STAFF REPORT
(One-Step Final Plat)

CASE NUMBER: SUB 2000-82 -- SAVANNAH PLACE ADDITION

LOCATION: West side of Tyler, South of Maple

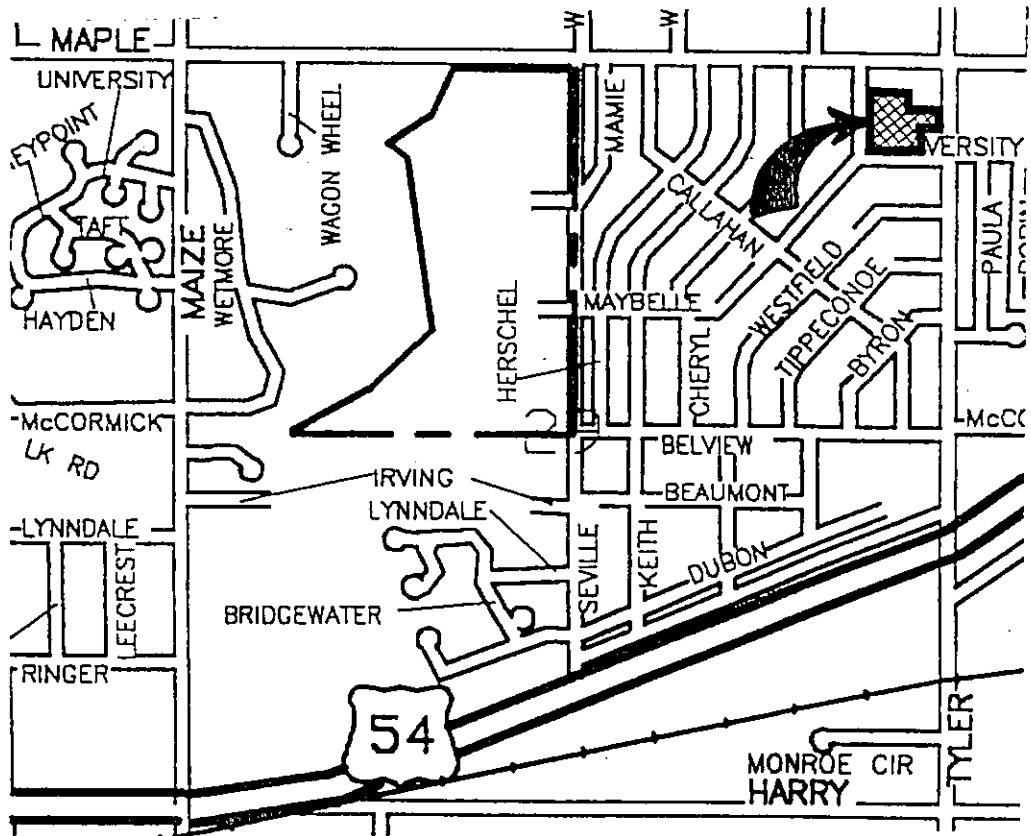
SS ext to lot 2
